Access Compliance Report

Public Rights-of-Way

Intersection ID: 53165	Main Street: DIXIE_RIVER_RD	Cross Street: N/A	Location: NW
ADA ID: 7695164F8BAE	Ramp Type: Perp	Initial Pass/Fail: Fail	Overall Compliance: No
Severity Score: 8.75			
Codes/Mitigation Info/Possible Solution		Field Measurements/Component Compliance

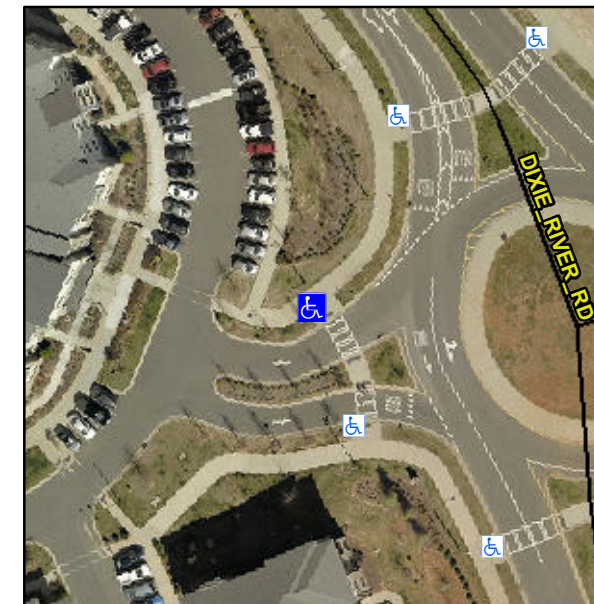
Not Found, R304.5.1

Compliance	Description	Data	Compliance	Description	Data
N/A	Ramp Length (in)	96.0	Yes	Ramp Slope (%)	8.1
No	Ramp Width (in)	46.0	Yes	Ramp XSlope (%)	1.5
N/A	Flare Type LT	N/A	N/A	Flare Type RT	N/A
N/A	Flare Slope LT (%)	N/A	N/A	Flare Slope RT (%)	N/A
N/A	Flare Traversable LT?	N/A	N/A	Flare Traversable RT?	N/A
N/A	Landing Length (in)	N/A	N/A	DWS Provided?	N/A
N/A	Landing Width (in)	N/A	N/A	DWS Contrast?	N/A
N/A	Landing Slope (%)	N/A	N/A	DWS Length (in)	N/A
N/A	Landing X Slope (%)	N/A	N/A	DWS Full Width?	N/A
N/A	Landing Curb? (Y/N)	N/A	N/A	DWS Offset (in)	N/A
N/A	Shared Landing?	N/A			
N/A	Gutter Ponding?	N/A	N/A	Gutter Slope (%)	N/A
N/A	Gutter Lip Ht (in)	N/A	N/A	Gutter X Slope (%)	N/A
N/A	Painted X Walk1?	Yes	N/A	Painted X Walk2?	N/A
	X Walk 1 Direction	To S		X Walk 2 Direction	N/A
N/A	X Walk 1 Width (in)	107.0	N/A	X Walk 2 Width (in)	N/A
	X Walk 1 Slope (%)	0.7		X Walk 2 Slope (%)	N/A
	X Walk 1 X Slope (%)	2.2		X Walk 2 X Slope (%)	N/A

Remove & Replace Entire Ramp.
